SEWAGE DISPOSAL SYSTEM

HOWARD COUNTY HEALTH DEPARTMENT

SUBDIVISION River Park Estates LOT 39 ROAD 1019 Taylor Park Road

REPAIR - PURPOSE - SEPTIC SYSTEM HAS FAILED.

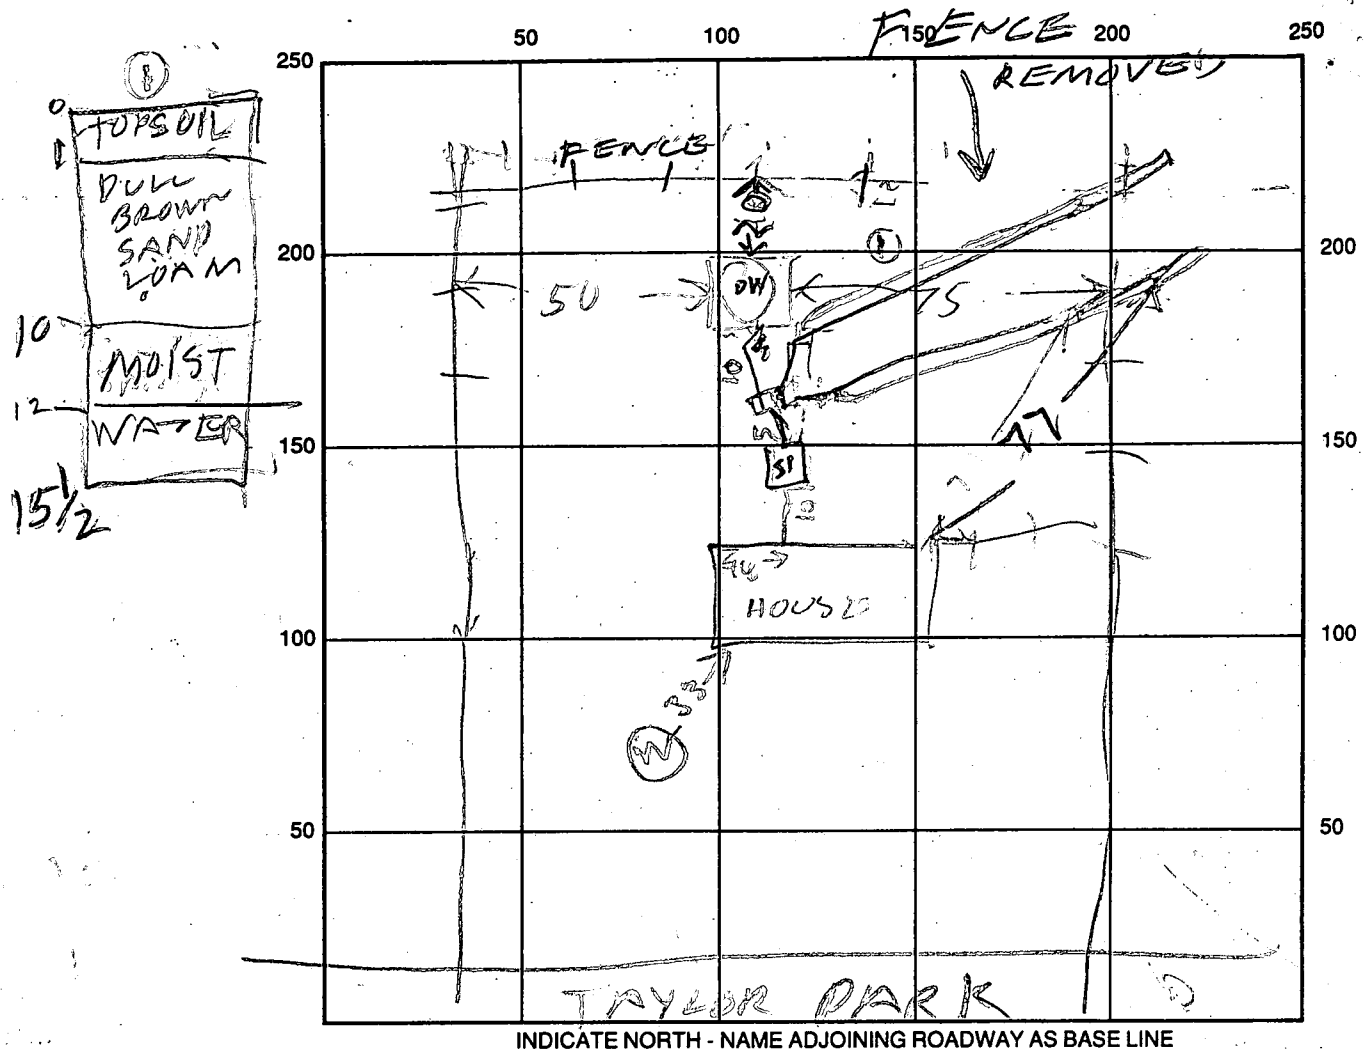
Call for inspection when ground is opened so sanitarian can recommend repair. 4/22/93

SHALLOW TRENCHES - 3 FT 7 WIDE 6-7 FT DEEP 2 FT
STONE & RUN TRENCHES OVER TANK USE
DRY WELL AS AN OVERFLOW AFTER DRAIN
FIELD IS FULL RH

WOLD	DATE	ABSORBENT AREA	PERMIT	START	STOP	SQ. FT.	START	STOP	TIME	REMARKS
1	5/21/93	51	945	947	947	953	6			PERCOK SHALLOW
1	5/21/93	3	958	1000	1000	1002	2			SYSTEM
	5/193									TRENCHES OK. IIR TRENCHES RILL UP, OVERFLOW WILL GO TO OLD DRY WELL R/H

LOT 39 SECTION 4 RIVER PARK ESTATE
3RD DISTRICT R40 ZONING

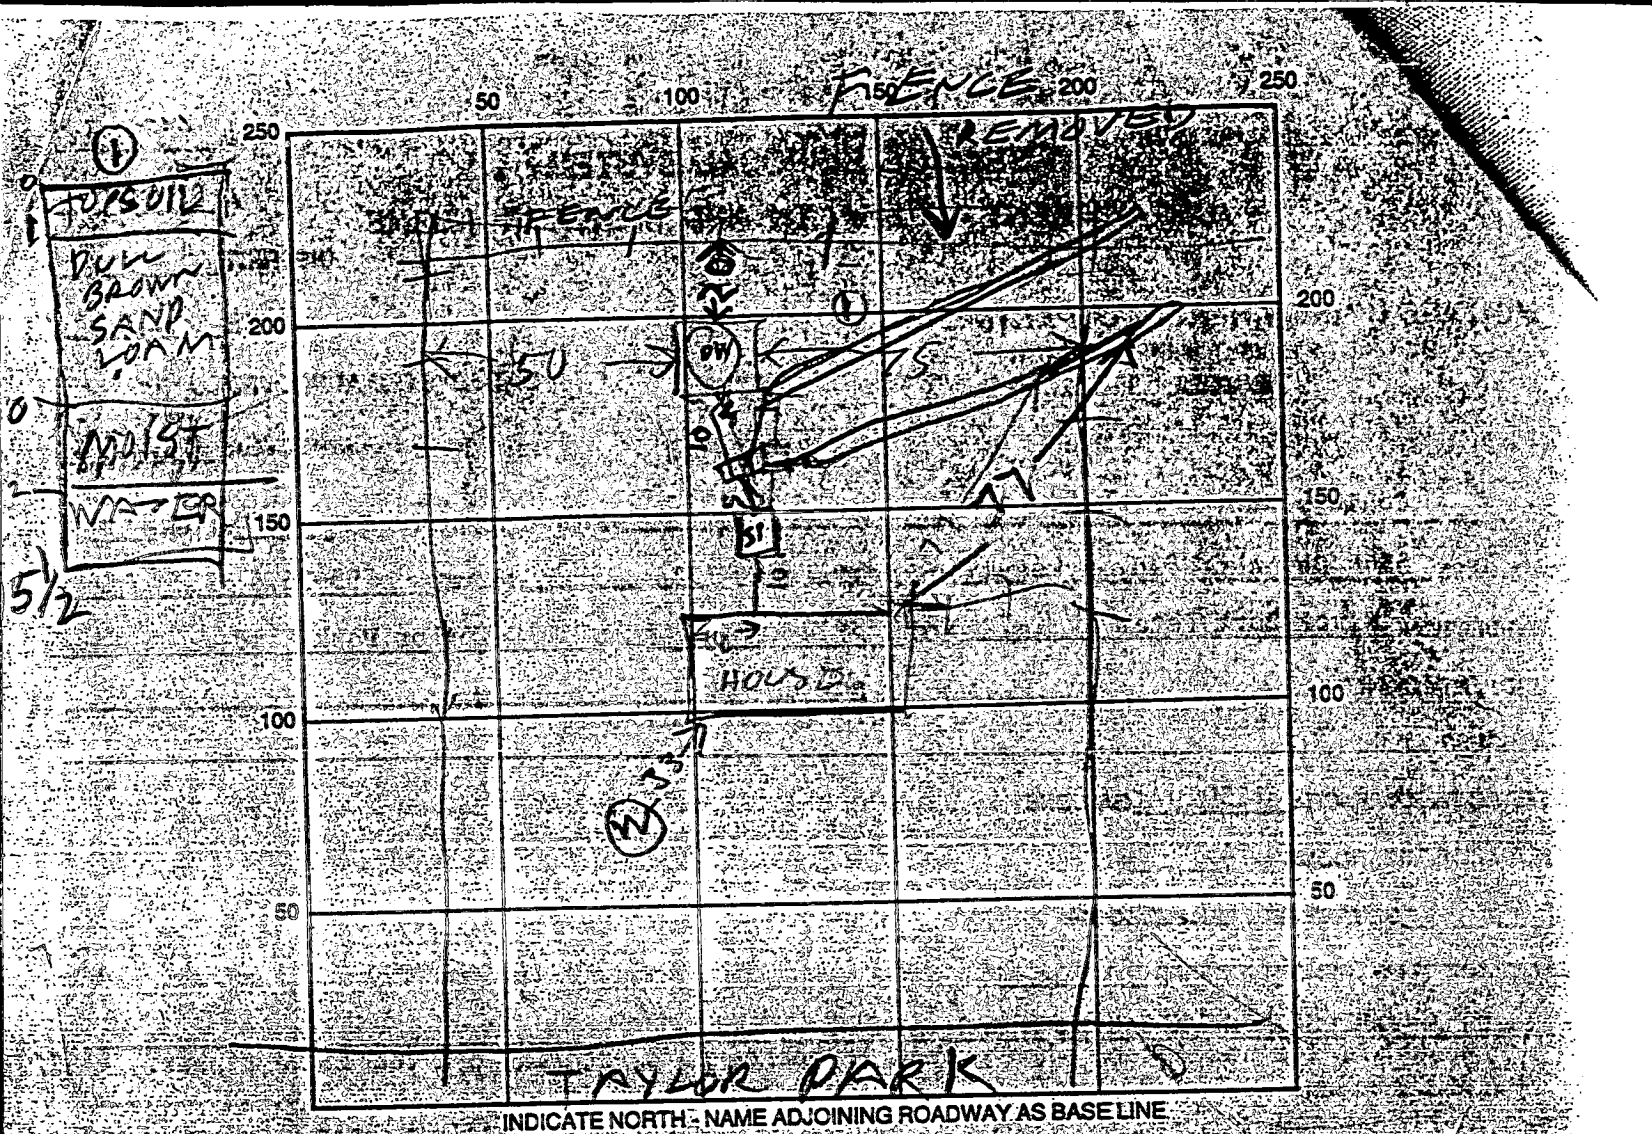
21' POOL WOULD BE PLACED 36' FROM HOUSE
 17' FROM FENCE
 20' FROM TRENCHES
 20+ FEET FROM SEPTIC TANK
 DEPTH 48 inches
 ROUND

7/18/94
 Proposed pool location. OK, no impact to
 existing well or septic OK to proceed
 Amy McMullen
 LOT 39

HOUSE LOCATION

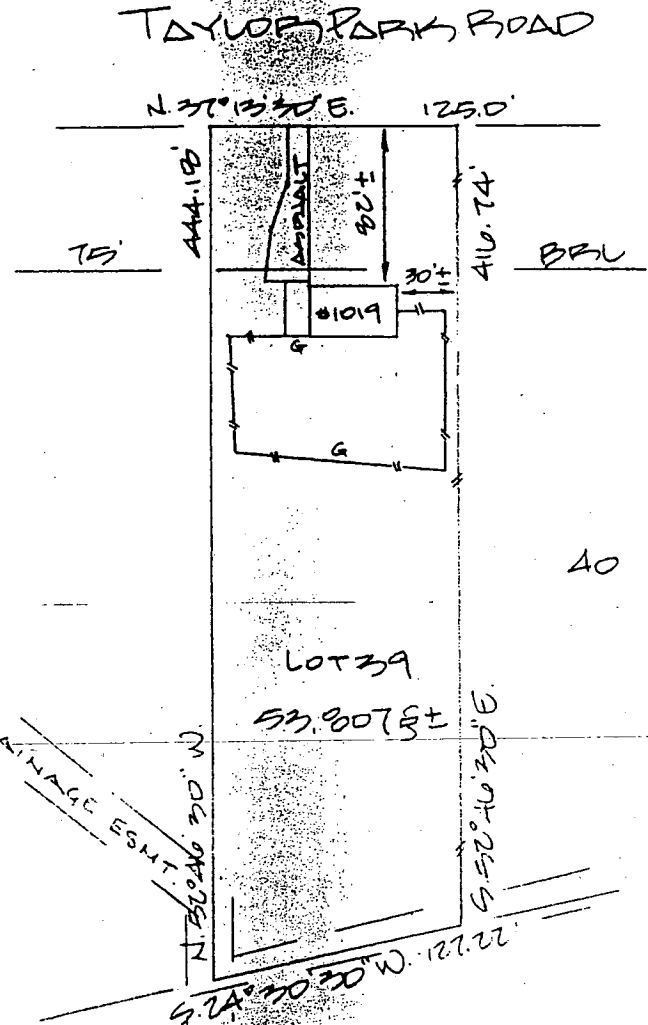
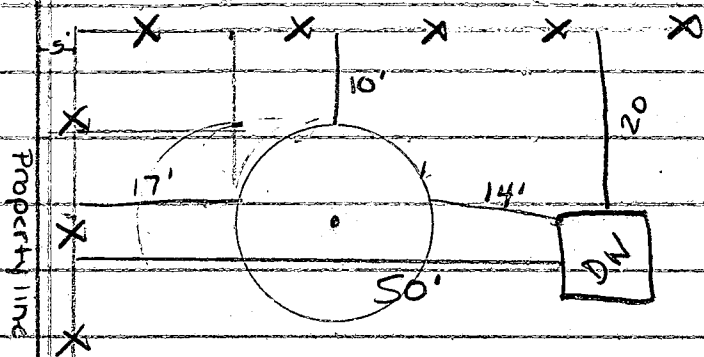
If they put pool where they say -
they will only be 14' off the
drywell.

Must move to left 6' - (make the
left side of the pool 11' off
the fence)

- Pool will be 17' off the property
line, not the fence. This will
make the pool 19' off the
DW.

- Recommend approval
